**Report of the Committee on  
Safety to Life  
Technical Correlating Committee**

**Committee on Means of Egress**

**Figure 1**  
**Estimated Number of CPSC/NEISS Stair-Related Injuries**  
**Treated in U.S. Hospital Emergency Departments**  
**Using Data Adjusted for Changes in CPSC/NEISS Sampling\***

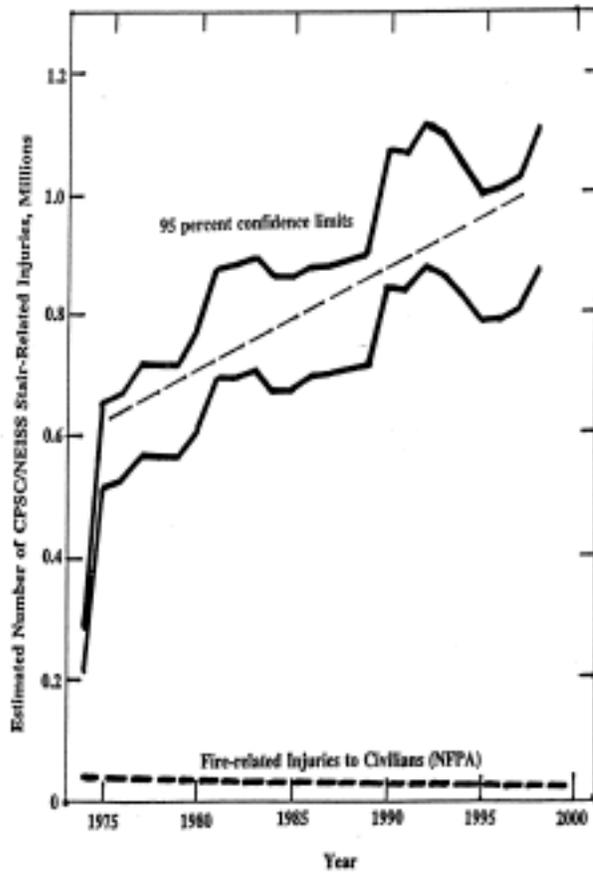
Table 1 and Figure 1 clearly suggest that stairway-related injuries have not been effectively controlled. Indeed, as noted above, the trend line for stair-related injuries is upward while that for fire-related injuries to civilians is downward. Similarly, in the USA, motor-vehicle related fatalities in terms of vehicle miles driven have been dropping (by about one-half). During the 25-year period shown in Figure 1, population growth in the U.S. has been only about 1 percent a year. Thus growth in stair-related injuries is not explained by population growth nor, in my professional opinion, by increased home stair usage.

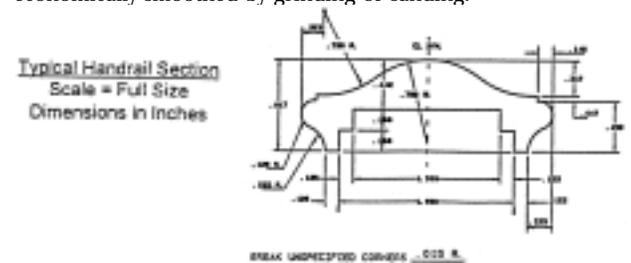
**SUBSTANTIATION:** Exception No. 1 to Paragraph 3-2.2.4.5.3 specifies that the edges of handrails have a minimum radius of 1/8 inch (3.2 mm). Such a requirement is of questionable validity and would most certainly eliminate many of the ordinary handrails currently in use.

The basis and source of the minimum 1/8 inch radius requirement is not known. However, it is well known that handrails with edges with curvatures of much less than 1/8 inch have been manufactured and used for years.

Depending on the material, method of manufacture, or desired appearance, the edges of handrail brackets may be chamfered, ground, extruded, or cast with edges that are specified to be "broken" to a radius as small as .015 inch. This industry practice has not resulted in the delivery of handrails that have not been found to provide satisfactory service.

To prevent injury or discomfort to the hand, it is not necessary to round all objects to a curvature as large as 1/8 inch. Many items commonly handled do not have radii defined edges. For example, cabinet handles, lever type door handles, wood and metal furniture, light switches, silverware, and so forth. Many of the items mentioned have square, chamfered or "broken" edges.

**Figure 1**

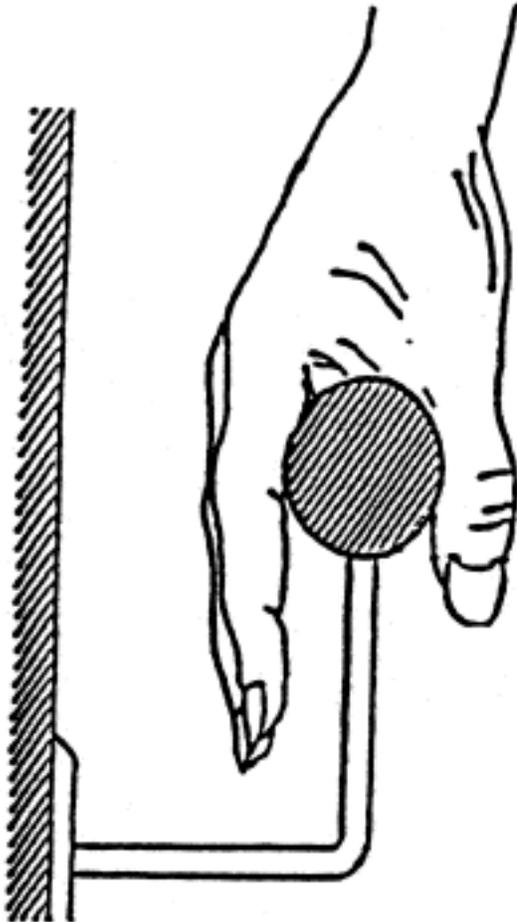
It is our understanding the basis for the 2 1/2 inches of clearance is to allow for the extended length of a person's fingers should they slide their hand along the handrail with fingers extended as shown in Figure 1 on the following page.

In studies of handrail shapes and handrail grips, several methods of grasping handrails are most often mentioned — the power grip, the pinch grip, and the hook grip as shown below in Figure 2.

None of the research data I reviewed made any mention of a stiff finger grasp such that 2 1/2 inches of clearance would be required as illustrated earlier in Figure 1.
